August 18<sup>th</sup>, 2010

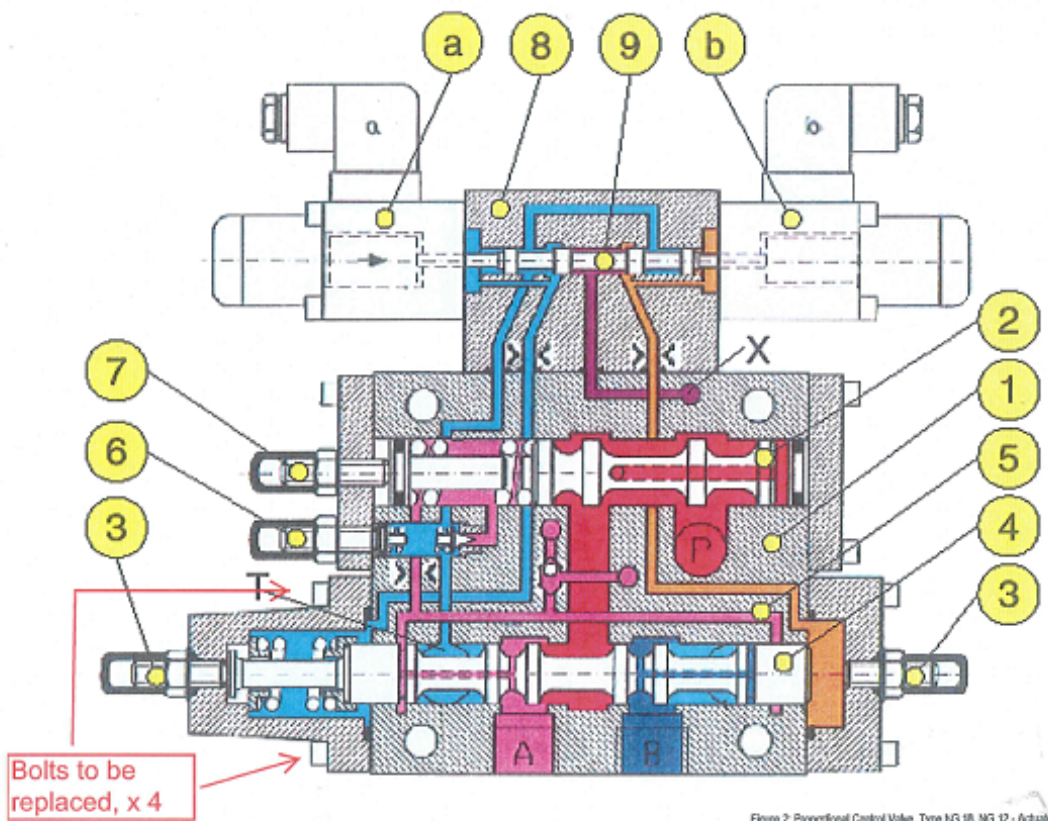
The end cap bolts are identified in the figure below.

Add to the service schedule for the miner to replace the bolts every 3 years. Minimum property class 8.8.  
 Add to the service schedule for the miner to check bolt tightness every 12 months. Maximum torque 18Nm.  
 Notify personnel of the requirement to fully isolate the machine prior to opening the access panel to the valve banks.
